# Requirements for Grid Connection of Generators : Ideas for improvements of the code.

Presented at Brainstorming Session 31/1/2018

This presentation describes a number of items detected by Eurelectric and VGB susceptible for improvements in the RfG NC. Also interactions with the IGDs and with provisions in other codes are included.

## Topic 2: Classification of PGMs (1/2)

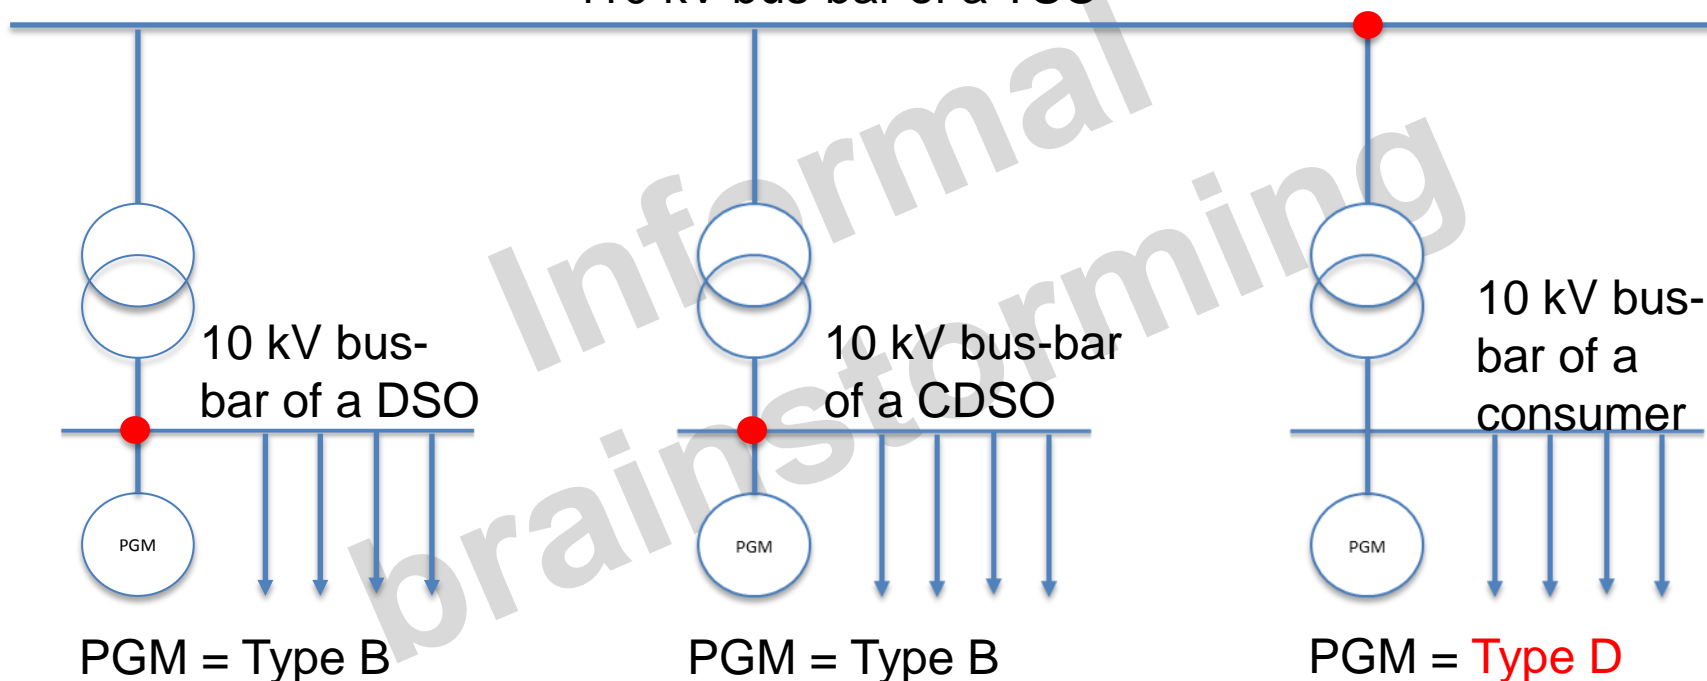
- Art. 5 defines a classification of power generating modules (PGM) depending on their capacity and on the voltage at the connection point.
- Each PGM connected at 110 kV or above is defined as a type D, meaning that a photo-voltaic panel of 800 W at an industrial consumer, connected at 110 kV or above, is a PGM of type D and is treated identically as a nuclear PGM of 1000 MW.
- Some countries expect a class derogation for not using this voltage criterion.

- The GLSO imposes operational planning procedures in Part III for relevant PGMs type B,C and D without a definition of the notion “relevant” creating also **uncertainty**.
- The procedures are justified for a nuclear PGM but NOT for smaller PGMs at industrial sites.
- Those procedures will reduce the interest of large industrial consumers to install RES and cogeneration units at their site.

## Pump-storage devices (2/4)

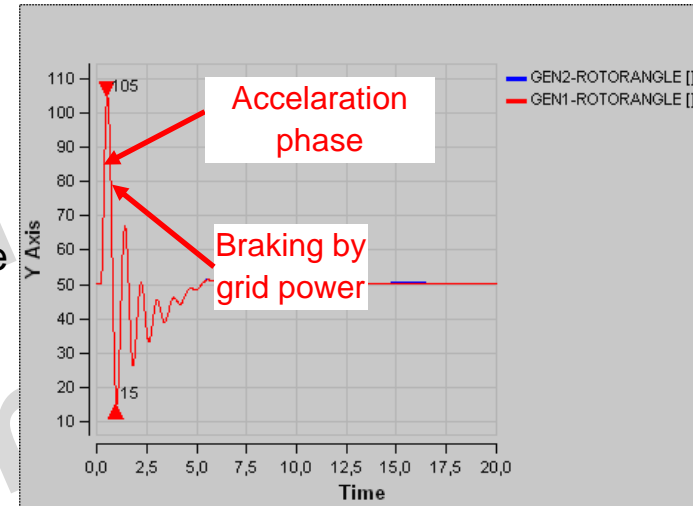
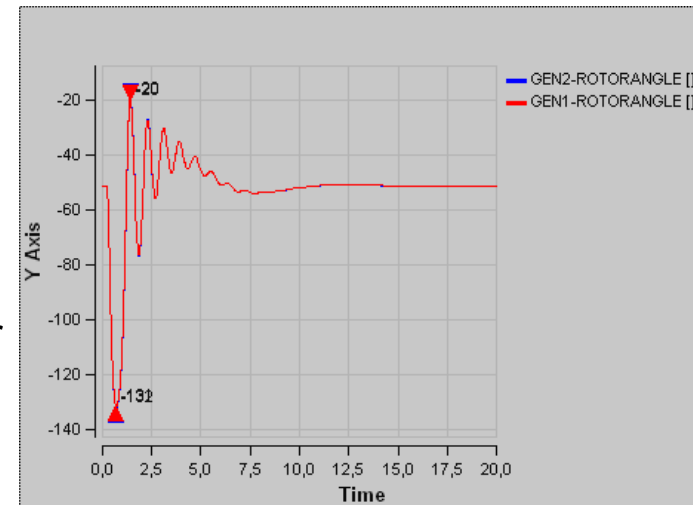
- During FRT the power of the turbine ( $P_{\text{Turbine}}$ ) is used to cover bearing losses, generator losses and to accelerate the rotor ( $P_{\text{accelerate}}$ )
- $P_{\text{accelerate}} = P_{\text{Turbine}} - P_{\text{Losses}}$
- After voltage recovery, the rotor is forced to original rotor angle position by the grid.

- FRT in pump-mode is more difficult to achieve, since the rotor slows down ( $P_{\text{slowdown}}$ ) by water pressure + bearing losses + generator losses leading to a larger rotor angle.
- $P_{\text{slowdown}} = P_{\text{Pump}} + P_{\text{losses}}$
- After voltage recovery, the rotor is forced from more far rotor angle to the original rotor angle position by the grid.
- Close to stability limit this process is highly non linear

Rotor angle in generating mode  $+105^\circ$

Rotor angle in pump mode  $-132^\circ$

## Topic 6: Pump-storage devices (3/4)

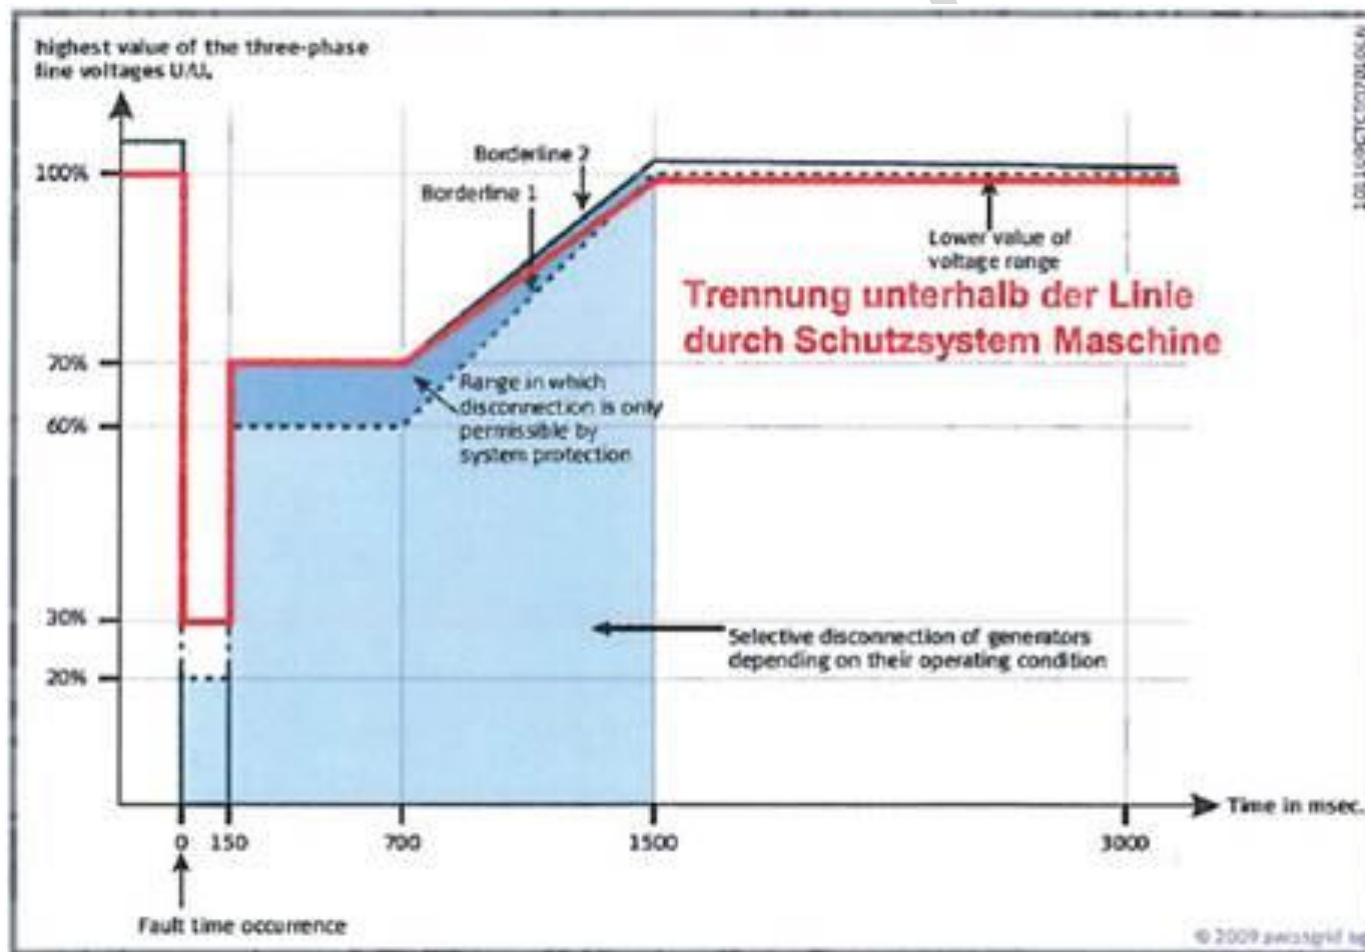
This graph shows the FRT capability of a recent plant in pump mode (build now) :  
At a voltage dip below 30%, the plant will trip (RfG table 7 imposes 0%)
